SUBMISSION TO AMENDMENT C295case TO THE CASEY PLANNING SCHEME CASEY FIELDS SOUTH & DEVON MEADOWS PRECINCT STRUCTURE PLAN

proUrban is pleased to provide this submission to the Victorian Planning Authority (VPA) in relation to exhibited Amendment C295case ('the amendment') to the Casey Planning Scheme – Casey Fields South and Devon Meadows Precinct Structure Plan (PSP).

MEMO

Figure 4 | Proposed allocation of land use

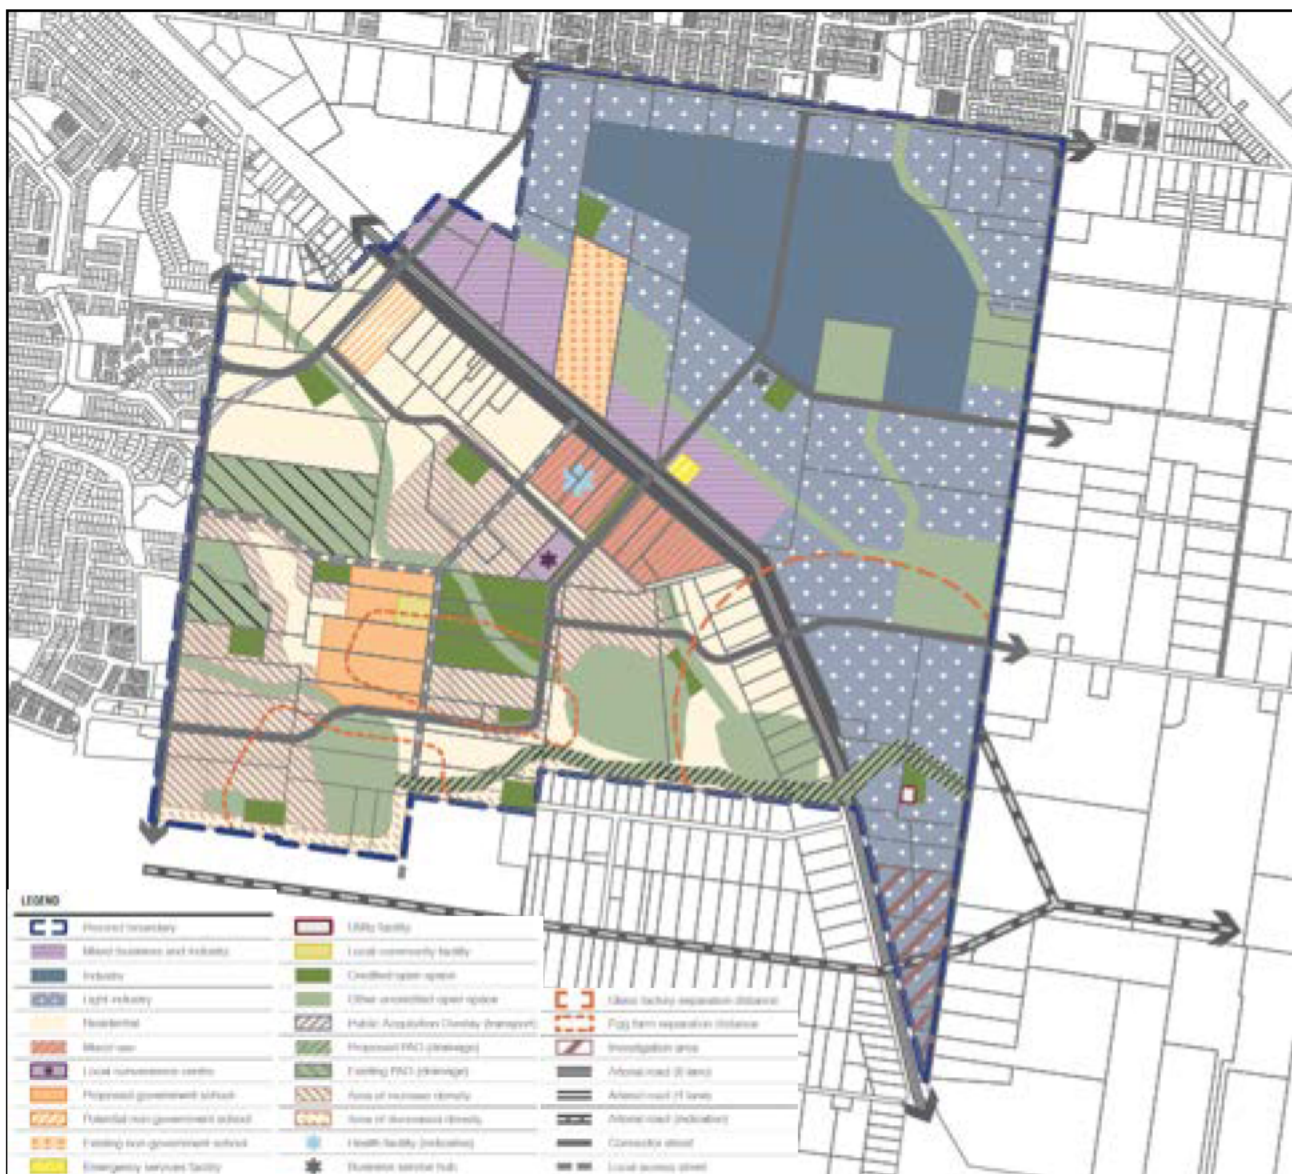
We request that the designated land uses be revised to further maintain flexibility and allow market forces to drive development in the precinct. While we appreciate the intention of the VPA to establish a central heart to the employment precinct, we consider the application of land uses should result in:

- The frontage to South Gippsland Highway and eastern interface to existing school to accommodate Mixed Business and Industry and the description of this use in the PSP be revised to reflect the ability to deliver industrial uses in this zone.

- Internal clustered core of the precinct to provide for industry.
 - Resulting in a higher total percentage of land allocation to increase supply in the context of the industrial land shortage

Please refer to the below plan prepared by Spiire which sets out a more appropriate employment precinct layout.

Figure 8 | Casey Fields South Employment PSP – Connector Street (Employment Avenue)

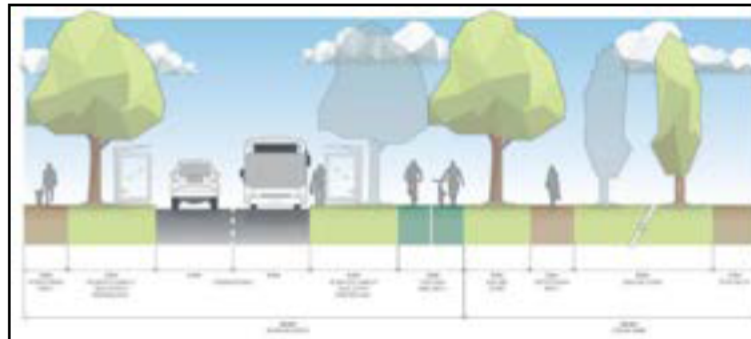
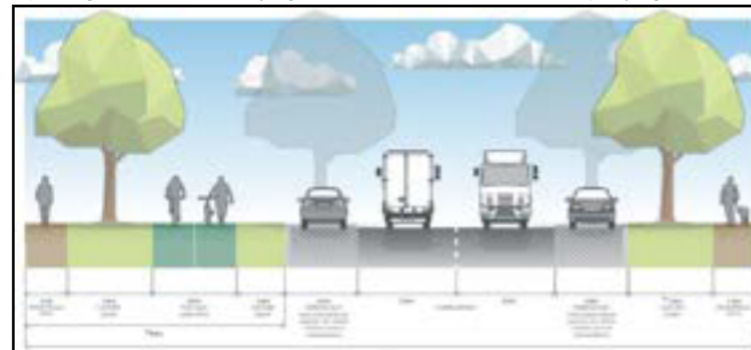
- The cross-section shows the 4m verges are required to accommodate planted swale, bus stops and parking bays. In industrial estates parking bays are required to be a minimum of 2.6m wide to cater to heavy vehicles. There will be minimal space for swales and any planting of trees will need to be widely spaced to allow for truck layovers.

Figure 7 - Alternative staging plan based on exhibited PSP

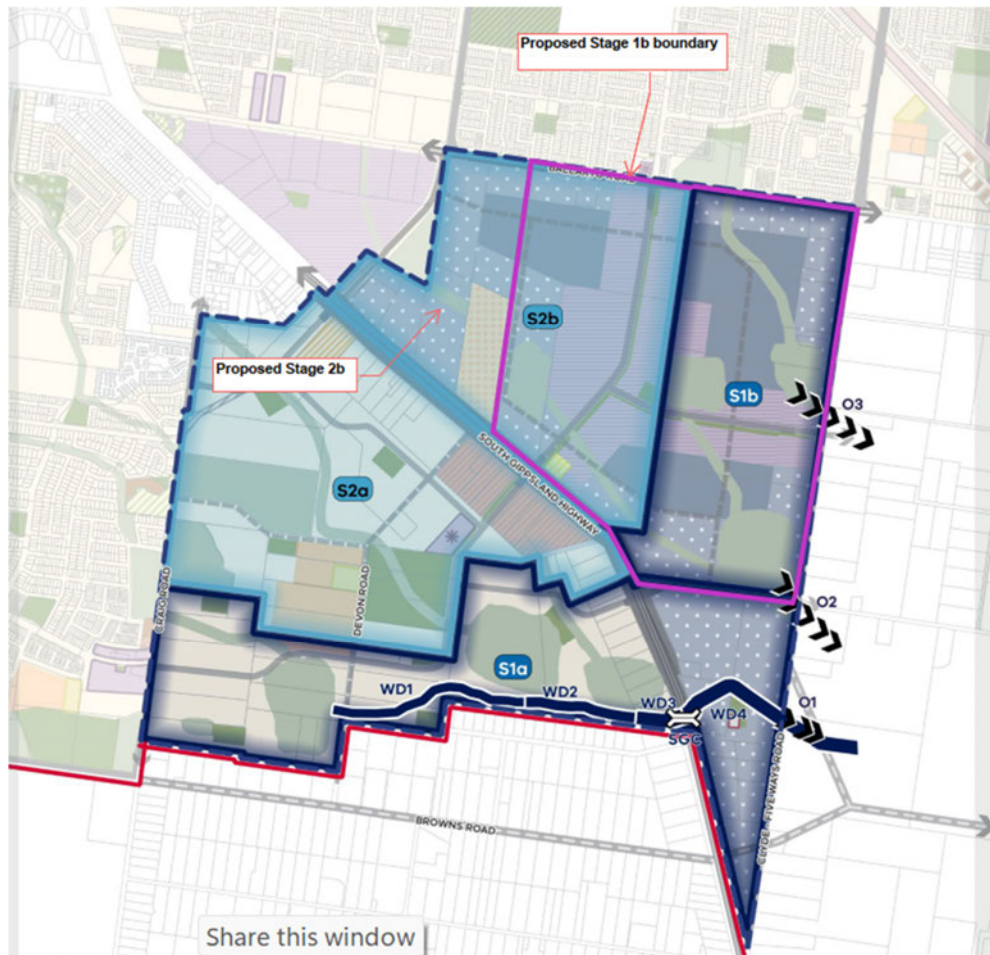
The current staging plan stifles the ability for other parts of the CFS PSP to be implemented earlier as stage 1b is predicated on the basis that a drainage outfall can be achieved. There is no evidence or timeframe around securing an outfall and thus Stage 1b boundaries should be increased further west to enable some of the PSP to be implemented in the event no outfall is realised in the short to medium term

The revised staging plan also enables alternative access points into the PSP.

RECOMMENDATION - Our opinion is that VPA should consider the below alternative staging plan.

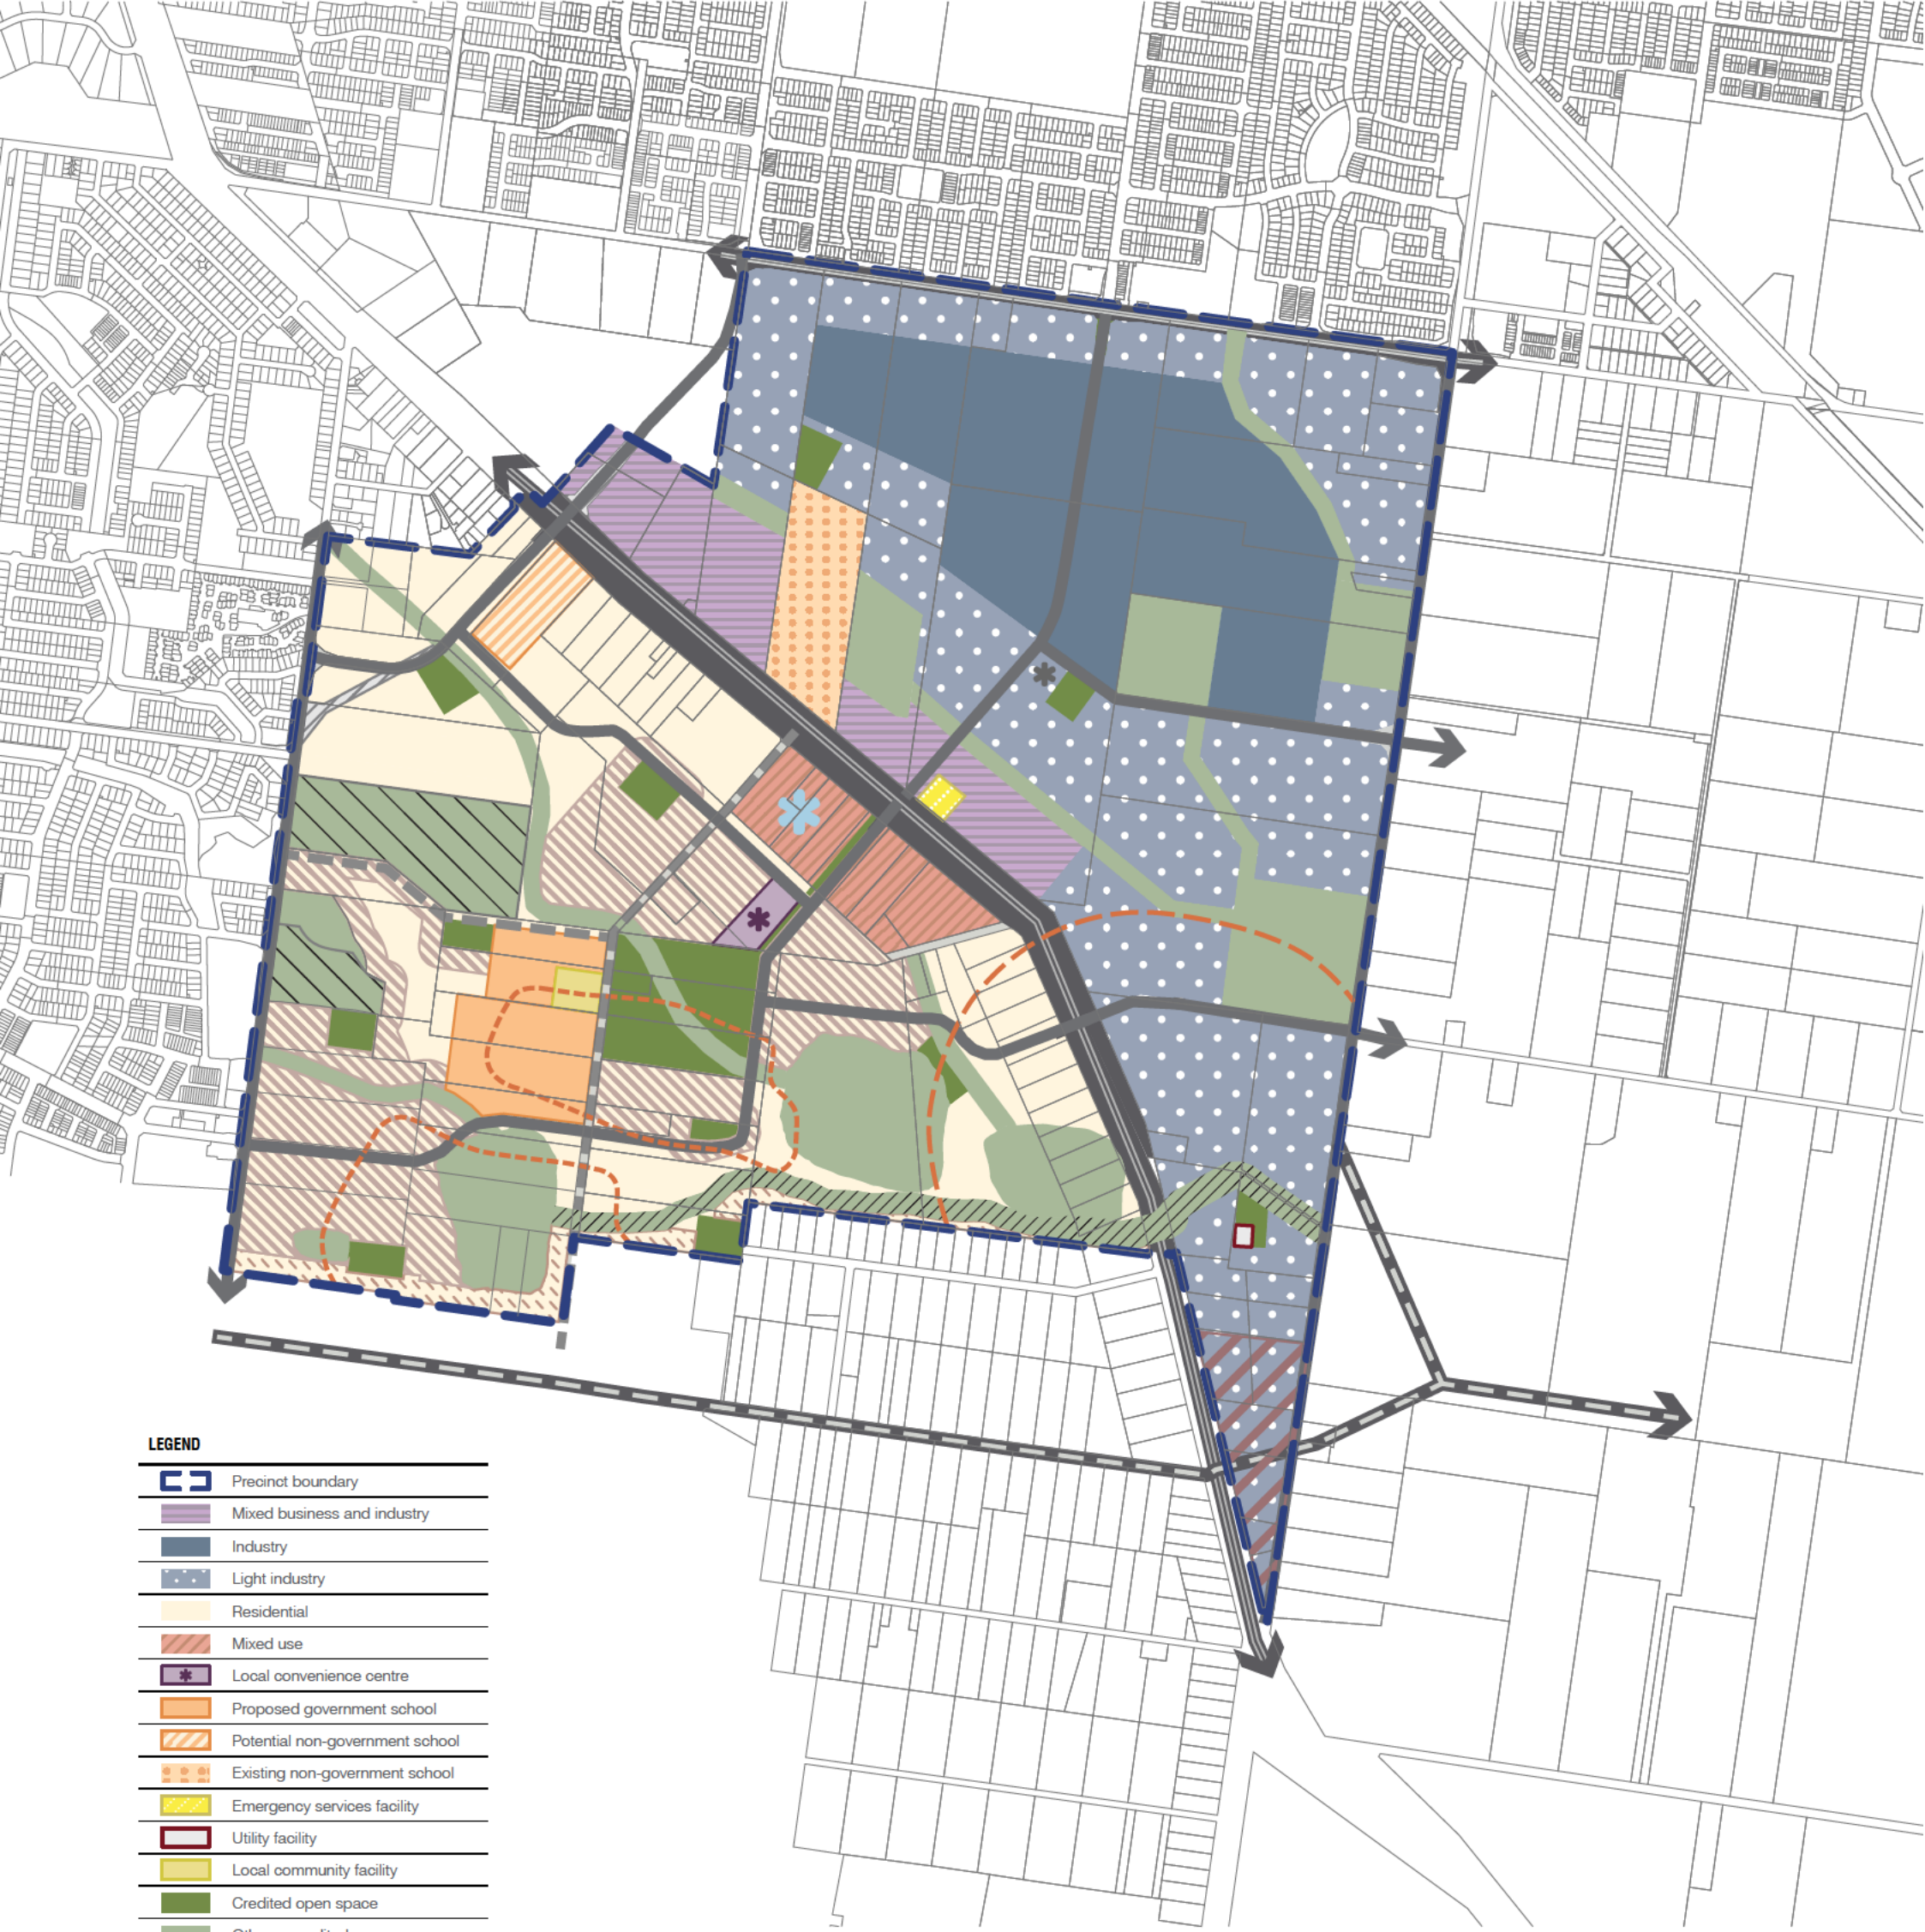
Volumetric requirements have been applied retrospectively by Melbourne Water in the past few years where “out of sequence” development is occurring. Avoiding detrimental impact is a key consideration of any downstream land owner. Given downstream land is already on a low lying flood plain, we are of the opinion that downstream land use will not change upon development. It is noted that flood impacts should not be altered, however pre-developed volumetric requirements should not apply.

RECOMMENDATION – Volumetric requirements should not apply to CFS PSP provided existing flood impacts downstream are not altered. It is supported that IWM opportunities should be investigated to assist waterway health and potable substitution ambitions.

Figure 5: Proposed Staging Boundaries

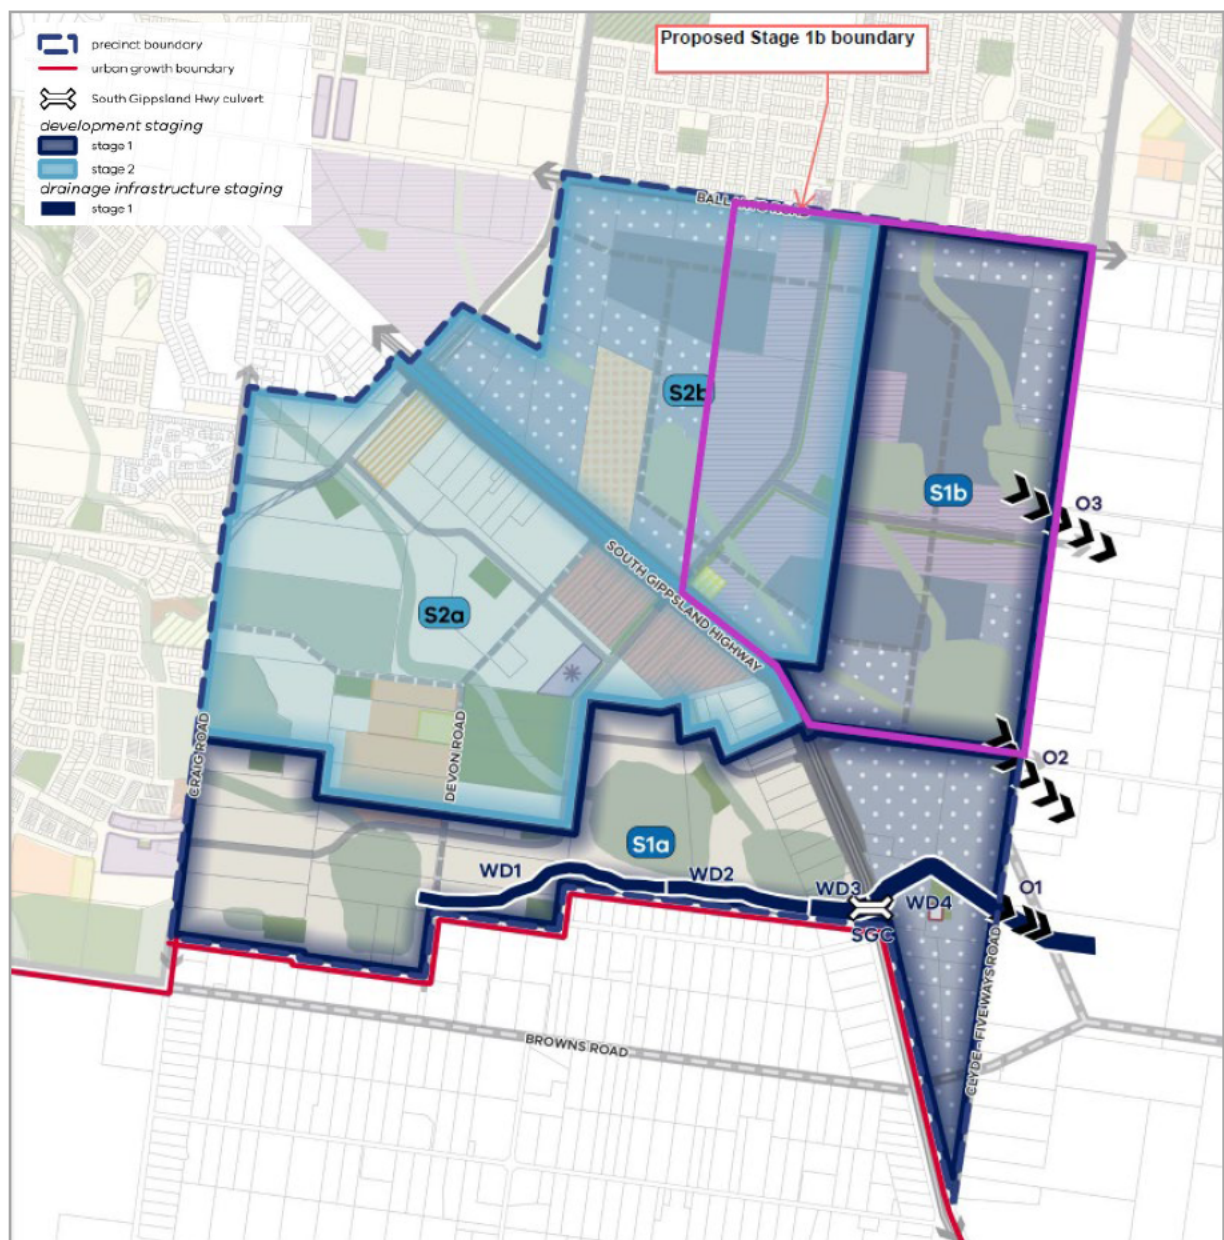
It is proposed to alter the staging boundary for Stage 1b to include the connector road intersections to South Gippsland Highway and Ballarto Road (IN-02 and IN-05).

- Road Network Connectivity – The South Gippsland Highway provides a significant connection to major industrial areas including Dandenong South and is likely to be a key traffic route for trucks accessing the site. Stage 1b does not provide convenient access to South Gippsland Highway.

- Inclusion of IN-02 and IN-05 in Stage 1b would allow for the Designated Bushfire Prone Area access requirements to be met.
- Inclusion of IN-02 and IN-05 in Stage 1b would allow for early access to the employment land to proceed without requiring funding from PSPs which are not yet completed (i.e. Clyde South). IN-02 relies on funding from Casey Fields (Residential) which is largely complete, while IN-05 relies on Devon Meadows PSP which is being planned in tandem with Casey Fields (Employment) PSP.

Figure 6: Casey Fields (Employment) PSP – Secondary Arterial Cross-Section (Proposed)

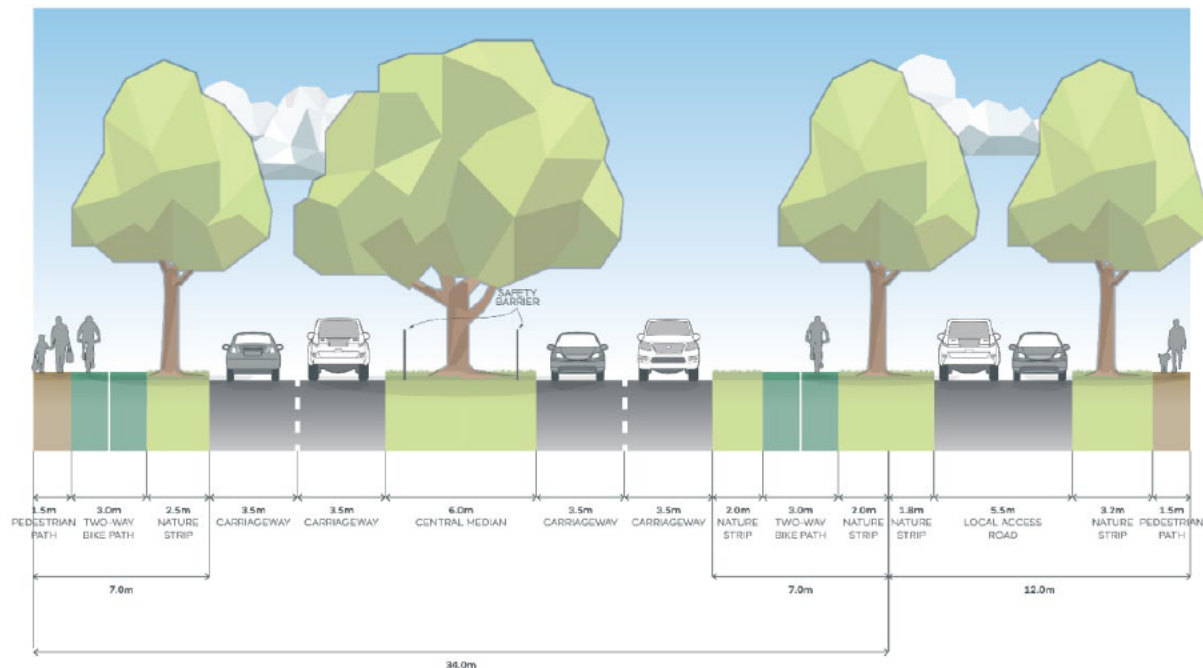
- 34m is a standard reservation width for a four-lane secondary arterial road.
- The reservation appears to apply to Ballarto Road as it is the only identified secondary arterial road within the Movement Network Plan.

- The “plan view” is based on residential frontages on both sides, which is not relevant in this instance, and shows footpaths provided within the 34m road reservation on one side but required to be provided outside of (in addition to) the 34m road reservation on the other side.

- Where the footpath is provided within the road reservation, it is hard up against the two-way bike path with no separation.
- There is no provision for on-street parking. This is common on PSP arterial roads. Parking is typically provided on frontage roads or service lanes and not on the main arterial road carriageway.

Figure 8: Casey Fields (Employment) PSP – Connector Street – Employment Avenue Cross-Section (20m)

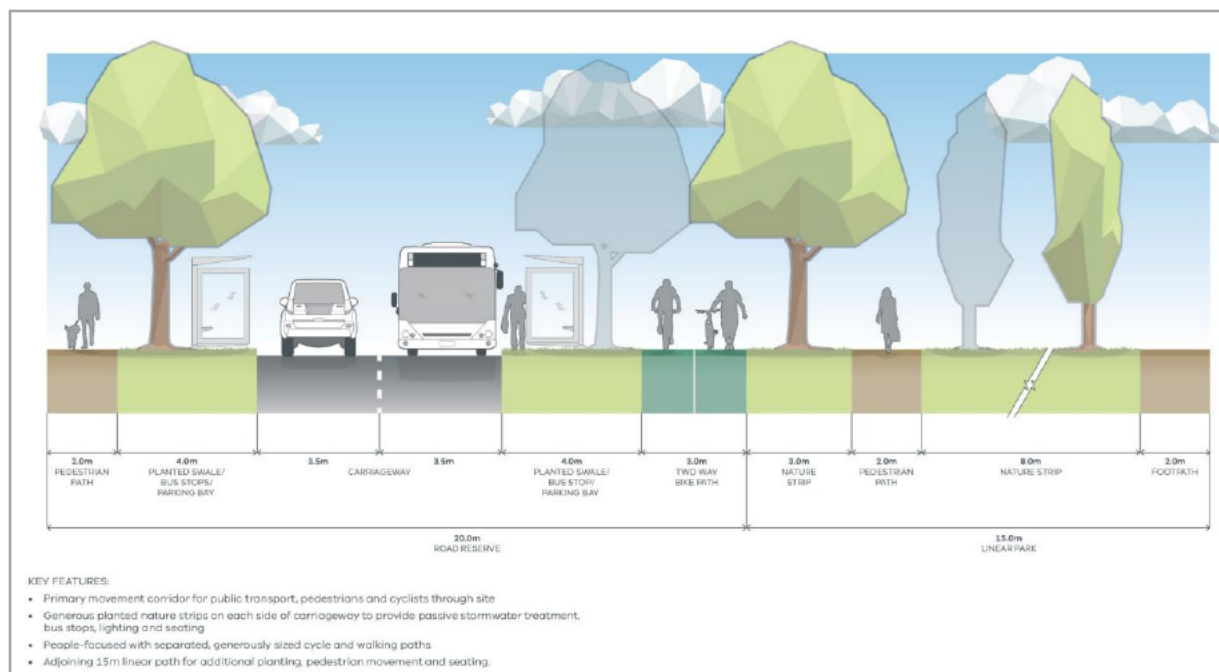
- A 7m wide carriageway (two 3.5m lanes) is well below the typical provision for an industrial subdivision and does not meet the Public Transport Guidelines for Land Use Development, which shows a minimum 8.4m carriageway for bus-capable roads where separate on-road cycle lanes are not included.

- The "key features" notation refers to the proposed nature strips as ... *"generous planted nature strips on each side of the carriageway to provide passive stormwater treatment, bus stops, lighting and seating"*. However, the cross-section shows the 4m verges are required to accommodate planted swale, bus stops and parking bays. In industrial estates parking bays are required to be a minimum of 2.6m wide to cater to heavy vehicles. There will be minimal space for swales and any planting of trees will need to be widely spaced to allow for truck layovers.
